# ACCELERATED DISTRIBUTION DEMONSTRATION SYSTEM

SUBJECT: Forwards second 10-yr insp interval Request for Relief 92-10 from 1980 Edition Section XI of ASME, including winter 1980 addenda to allow volumetric exam to be used for branch welds off main steam lines due to inaccessibility.

Subject: Duke Power Company  
Oconee Nuclear Station  
Docket No. 50-269, 270, 287  
Second Ten Year Inspection Interval  
Request for Relief 92-10

DUKE POWER COMPANY  
Request for Relief  
Inservice Inspection Requirement

No. 3MS-12B

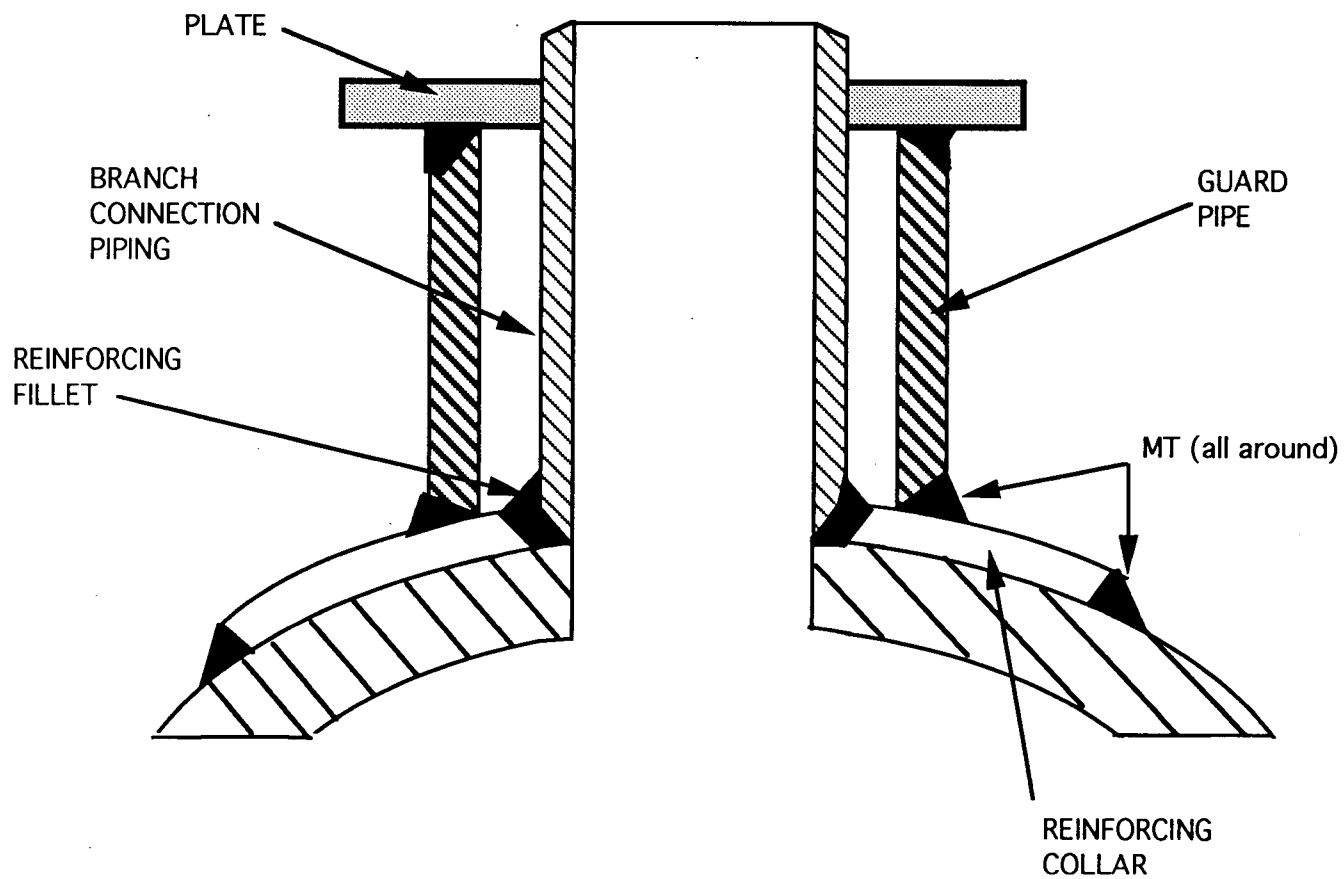
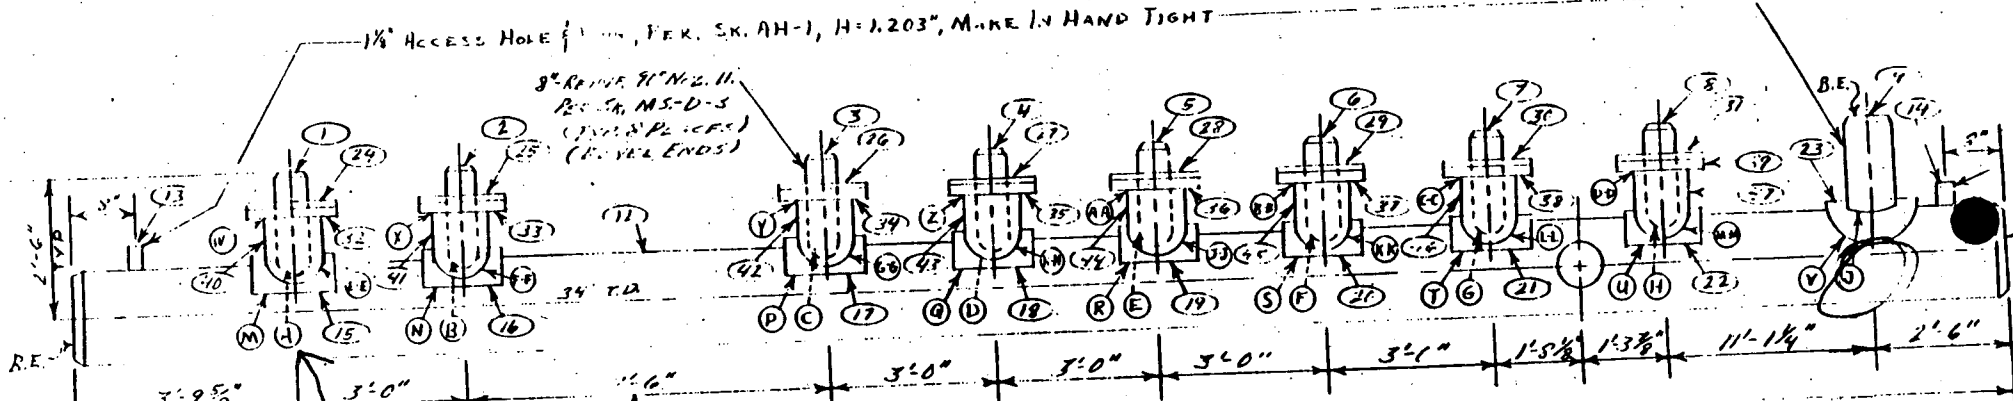
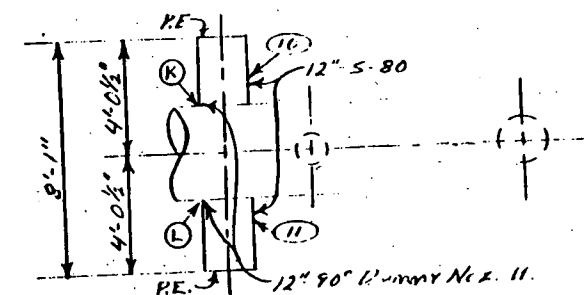
Welds are inaccessible for surface examination due to  
location of guard pipe. ( See attachment 2 for sketch.)

Surface examination (MT) of welds as shown on attachment 2.  
The system pressure test, when performed, will provide  
additional assurance of the integrity of the branch  
connection welds. These examinations will assure the safety  
and health of the public is not reduced as a result of this  
request.
